# 802.3cb Comment Resolutions

**Anthony Calbone 9/16/2016**

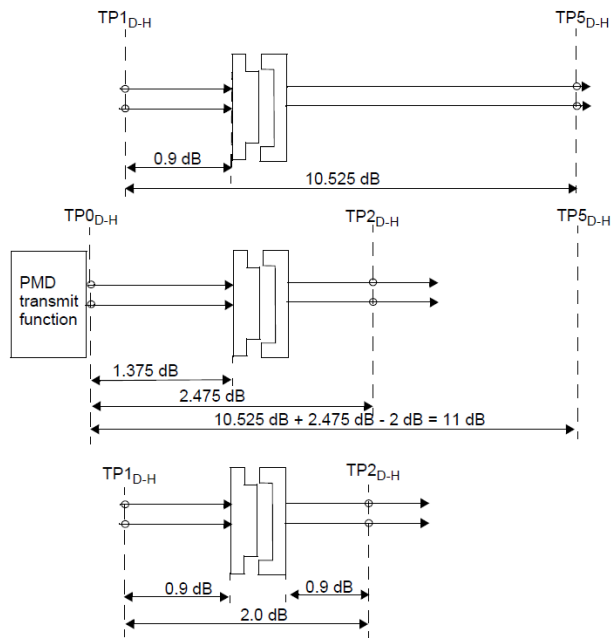
The definitions of the compliance points, the host compliance board, and the drive compliance board are not clearly shown in the figures. For instance, the output of PMD transmit function is labeled as TP0<sub>D-H</sub> in Figure 128A-1, but labeled as TP1<sub>D-H</sub> in Figure 128A-2. In Figure 128A-2, the loss from TP1<sub>D-H</sub> to the connector input is 0.9dB in the top figure but 1.375dB in the middle figure.

Define the compliance points clear.

In Figure 128A-1, the test point adjacent to the PMD transmit function is TP0 but here it appears to be TP1. Which is correct?

Include the TX PCB before TP1 or change the test point to TP0.

Why is the loss from TP1D-H to the connector 0.9 dB in one part of the figure and 1.375 dB in another part of the figure. What has changed? Similarly for the TP1 to TP5 insertion loss.

Clarify the difference between the diagrams in Figure 128A-2.

- Figure 128A-2 is incorrect in a couple areas.
- Solution is to modify the figure to match the figure below

NOTE-- The connector insertion loss is 0.2 dB for the mated test fixture.

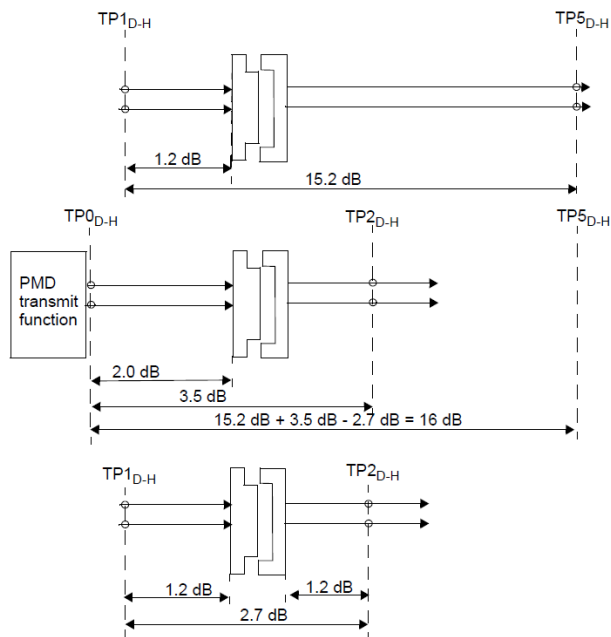
In Figure 130A-1, the test point adjacent to the PMD transmit function is TP0 but here it appears to be TP1. Which is correct?

Include the TX PCB before TP0 or change the test point to TP1.

Why is the loss from TP1D-H to the connector 1.2 dB in one part of the figure and 2 dB in another part of the figure. What has changed? Similarly for the TP1 to TP5 insertion loss.

Clarify the difference between the diagrams in Figure 130A-2.

- Figure 130A-2 is incorrect in a couple areas.
- Solution is to modify the figure to match the figure below

NOTE-- The connector insertion loss is 0.3 dB for the mated test fixture.

Figure 128A-5—Drive compliance board

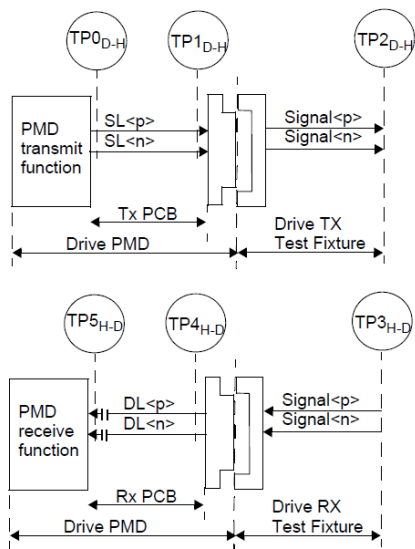
In the second part of the figure, it seems the test point at the PMD receiver function should be TP5H-D, the test point at the connection interface should be TP4H-D, the "Tx PCB" should be "Rx PCB", and the AC coupling capacitors shown between the TP4 and TP5.

Modify the figure per the comment.

- Figure 128A-5 is incorrect in a couple areas.
- Solution is to modify the figure to match the figure below to address the comments

PROPOSED ACCEPT.

Figure 130A-5—Drive compliance board

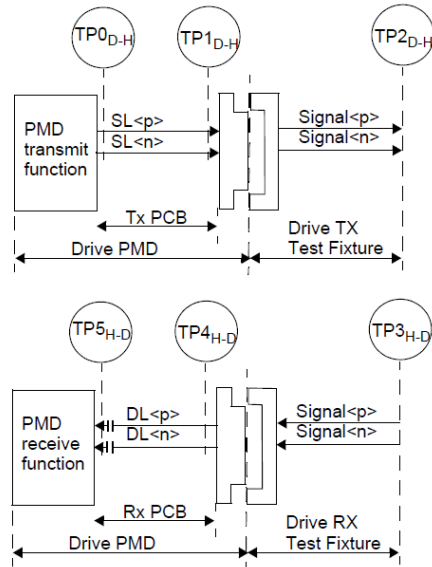
In the second part of the figure, it seems the test point at the PMD receiver function should be TP5H-D. the test point at the connection interface should be TP4H-D, the "Tx PCB" should be "Rx PCB", and the AC coupling capacitors shown between the TP4 and TP5.

Modify the figure per the comment.

- Figure 130A-5 is incorrect in a couple areas.
- Solution is to modify the figure to match the figure below to address the comments

PROPOSED ACCEPT.
